MEMORANDUM

SUBJECT: Special Use Permit and Site Plan Approval – 440 State Street

DATE: June 4, 2026

Request: Special Use Permit and Site Plan Approval to construct a 544 square-foot (SF) coffee shop with an accessory drive-through and associated site improvements on lands that currently comprise **430 State Street**, Parcel Number 12-03-220.200 and **440 State Street**, Parcel Number 12-03-220.300.

REVIEW ONLY NOT FOR CONSTRUCTION	
Date	MAY 2026
Scale	AS SHOWN
Sheet Number	C101
Project Number	5074.001.001

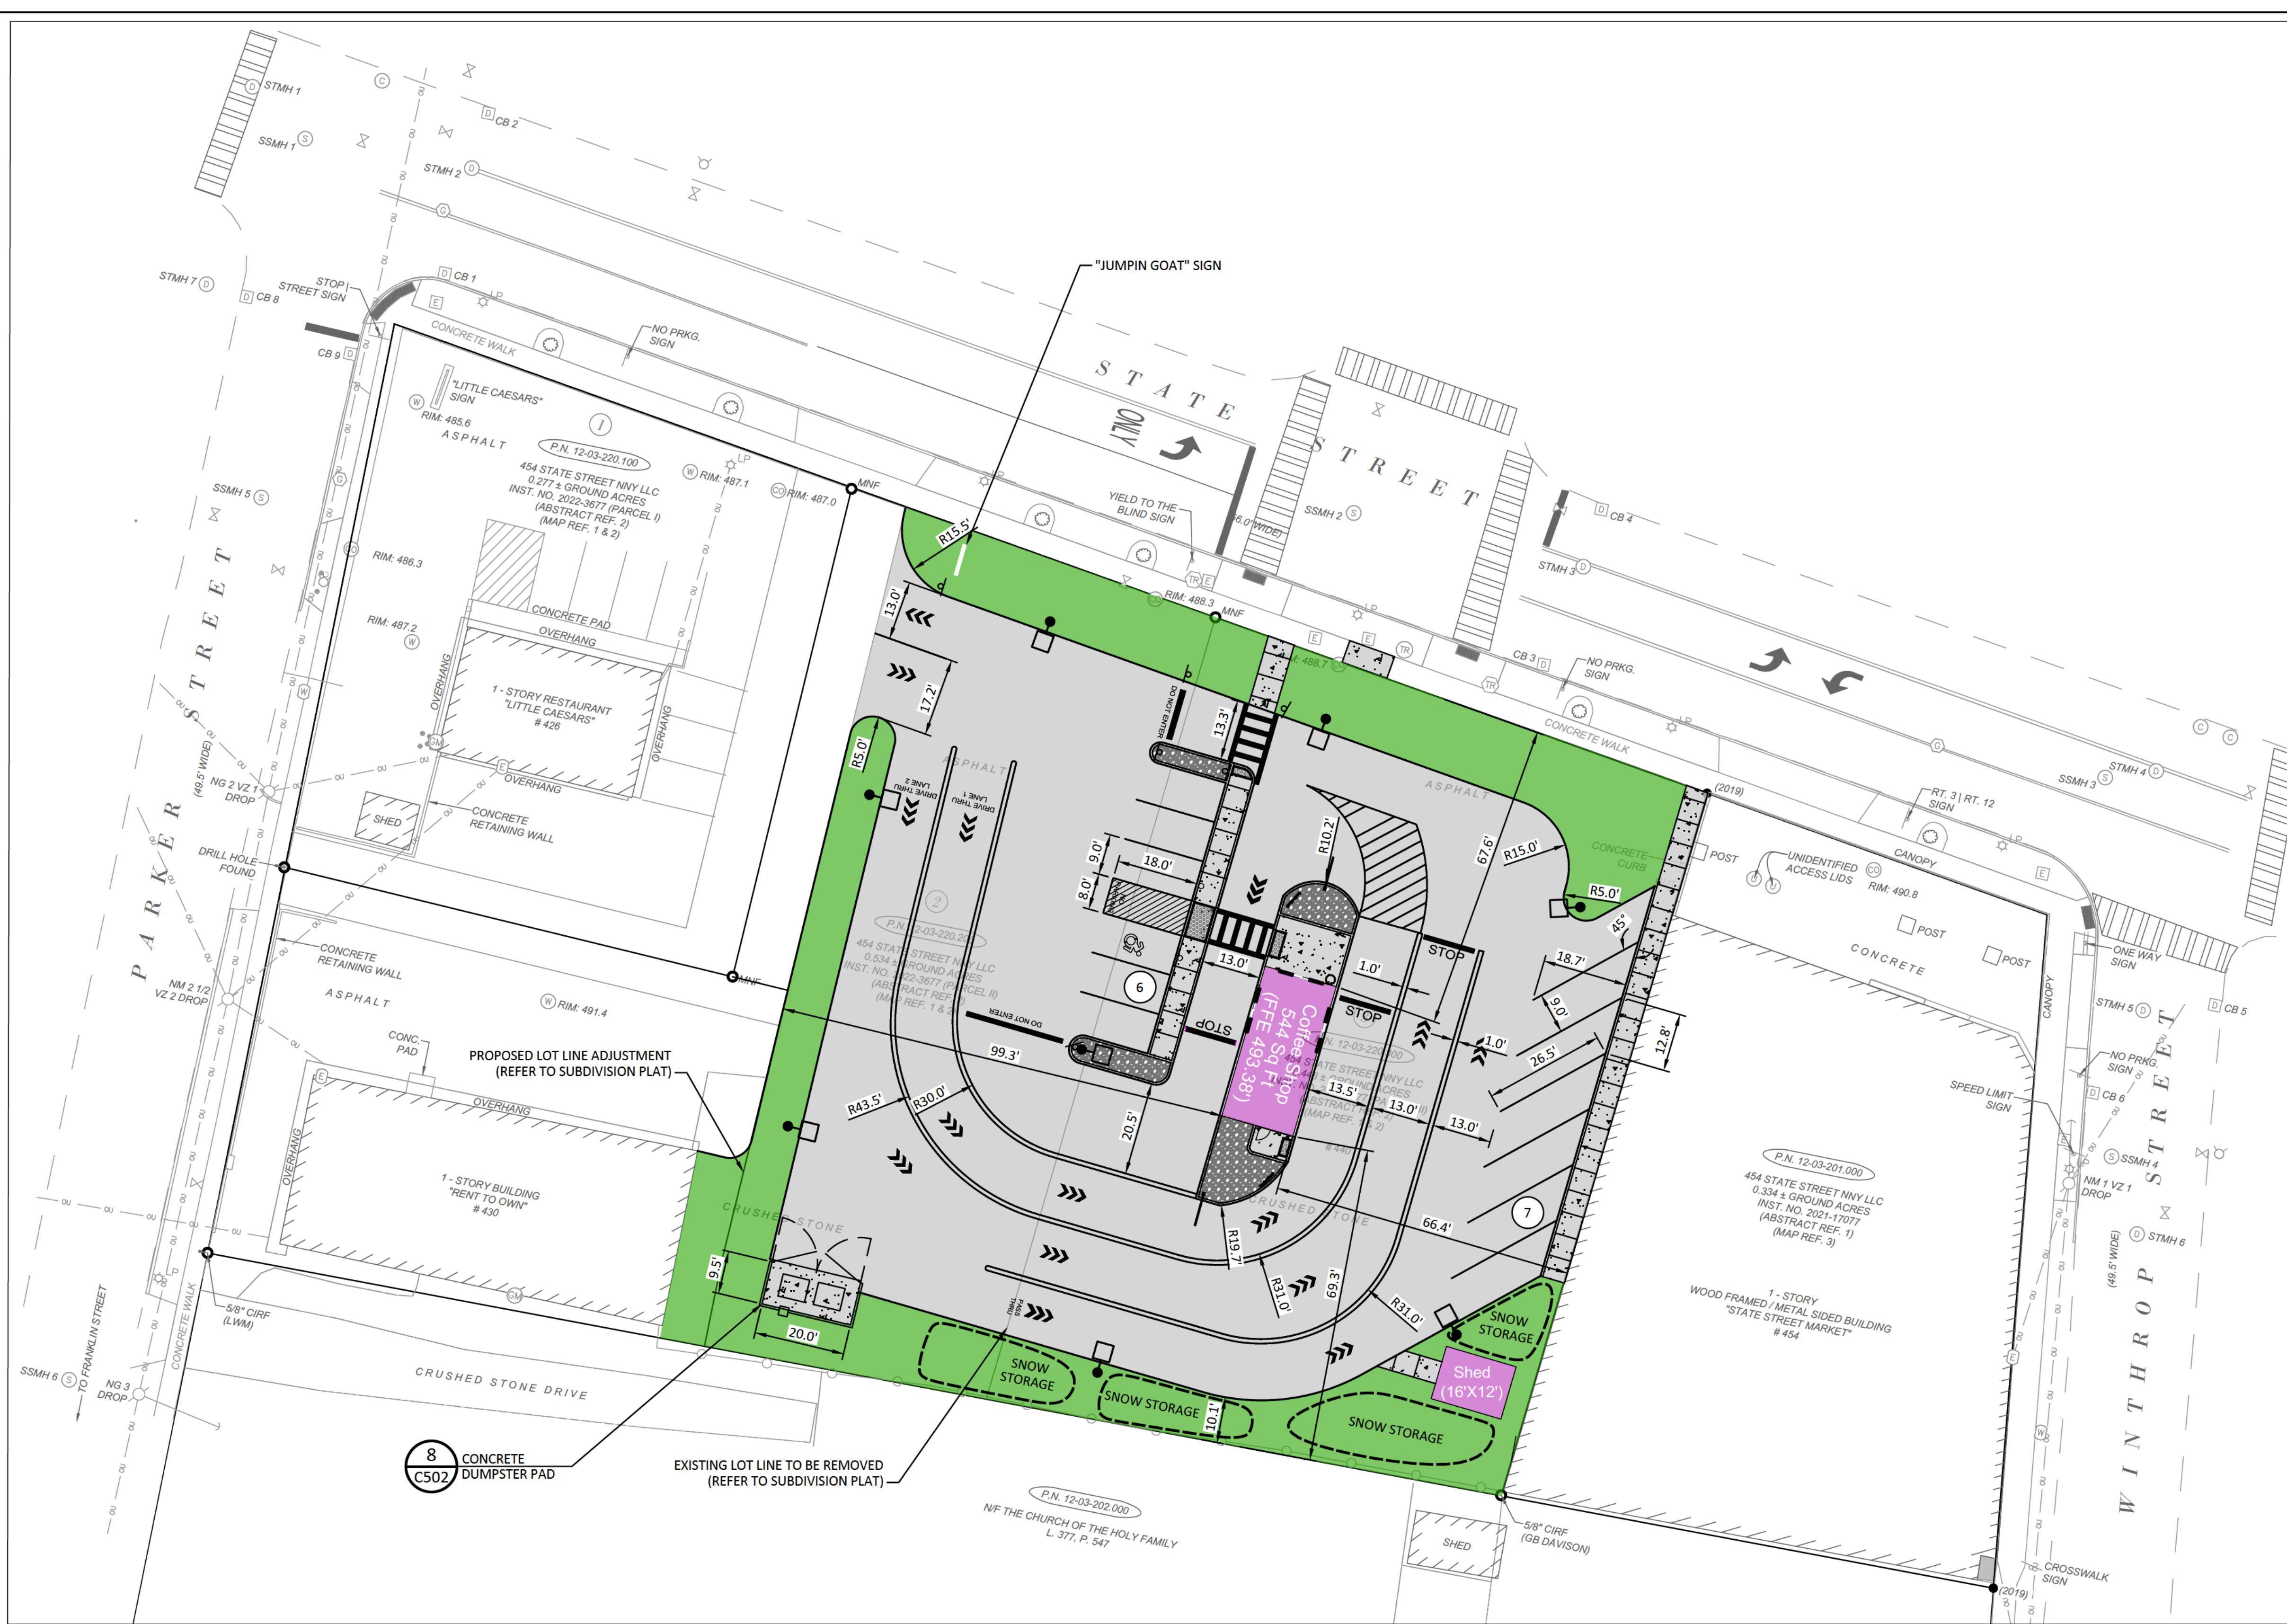
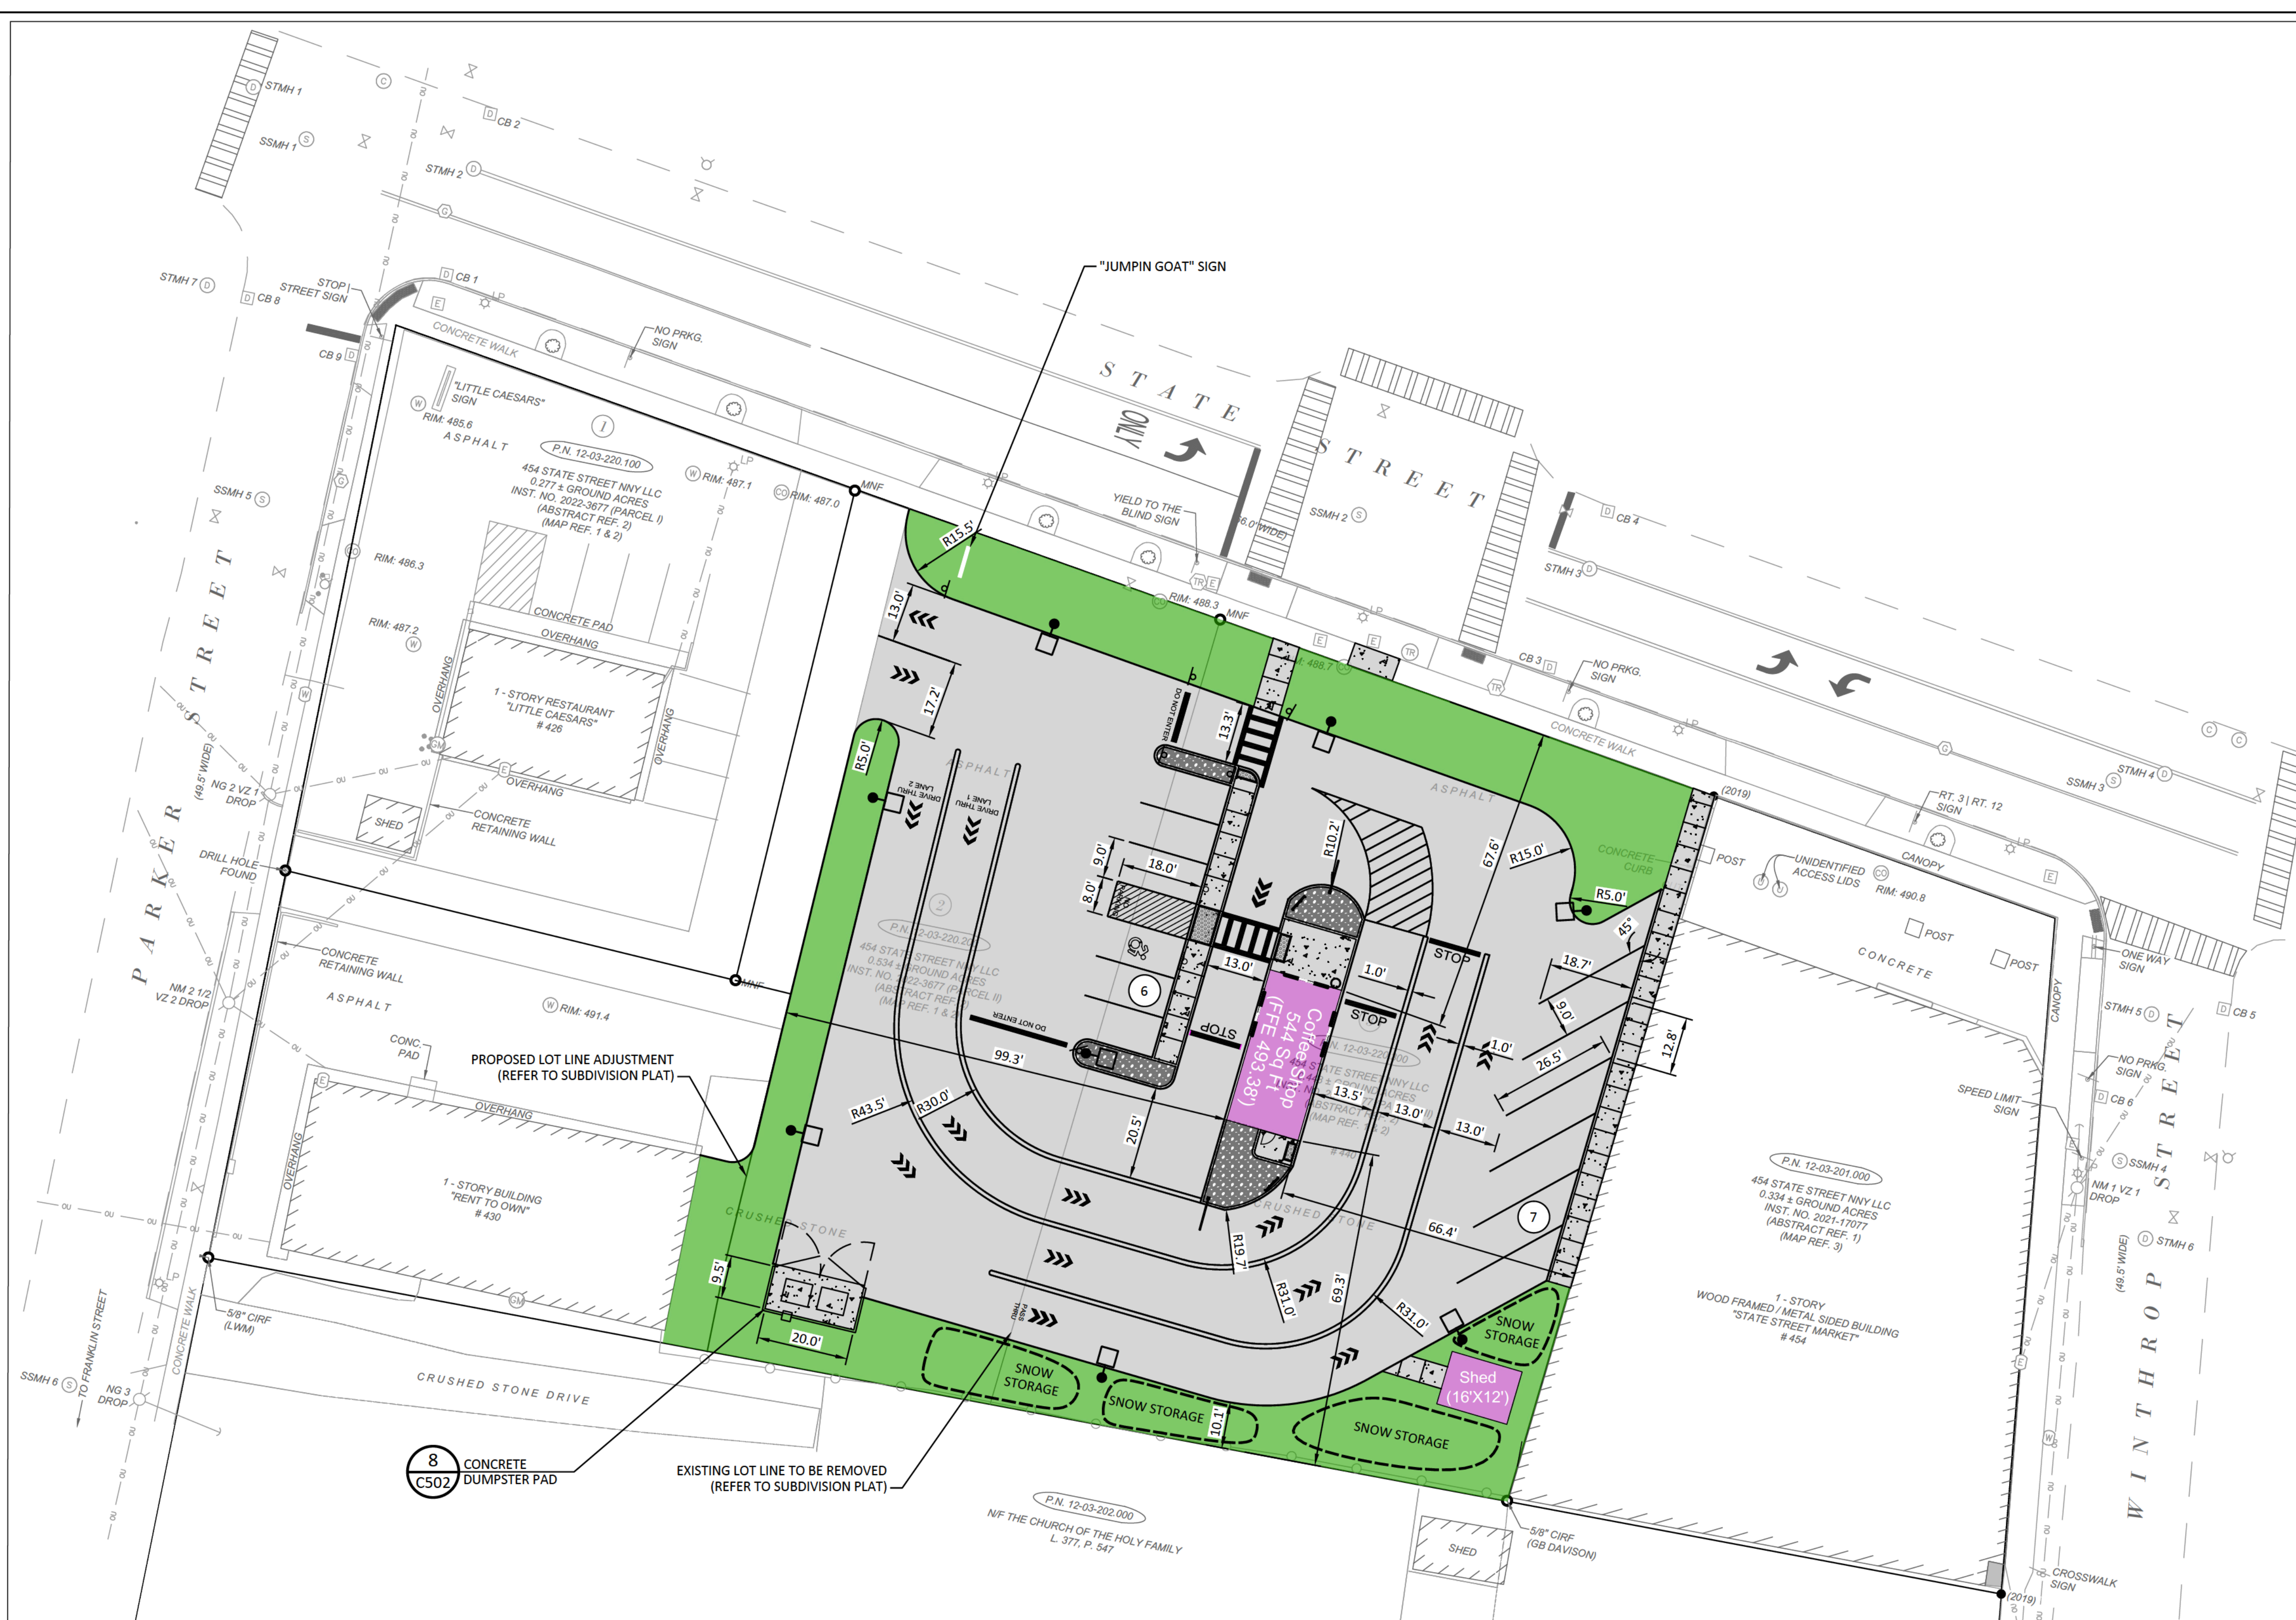
The intent of the ZBA's condition was to alert motorists using the pass-through lane to exit the queue (and the site) who are likely to be accelerating to the potential presence of crossing pedestrians. This condition of Variance #616 still applies to the northern internal crosswalk connecting from the State Street sidewalk to the internal sidewalk, which crosses the exit lane. The applicant is responsible for installing and maintaining two 11-2 pedestrian crossing signs on either side of this crosswalk. While these two signs, along with other site signage, are shown on sheet C503 in the site sign table, they are not clearly labeled on the site plan drawing. The applicant should therefore label the signpost symbols on the site plan.

The applicant is not proposing a detectible warning where the sidewalk crosses the landscape setback on the northern landing from the crosswalk across the pass-thru exit lane. This is a crossing across a vehicular lane and warrants a detectible warning in this location. The applicant shall add a detectible warning at this landing.

Finally, it is unclear if and where the applicant proposed interior curbing, and what effects it would have on ADA accessibility and site drainage. The applicant shall be prepared to address this at the Planning Commission meeting.

7. The applicant shall either relocate the proposed water service connection or prove that there is no conflict with the existing light pole.
8. The applicant shall revise the site plan to show the installation of two pedestrian crossing signs (11-2 in the Manual of Uniform Traffic Control Devices) on either side of the crosswalk connecting from State Street to the internal sidewalk island, as required by the Zoning Board of Appeals as a condition of Variance #616.

10. The applicant shall add a detectible warning plate on the landing at the northern end of the crosswalk across the pass-thru exit lane where the internal sidewalk crosses the landscaped setback area.

11. The applicant shall clarify if and where any interior curbing is proposed.
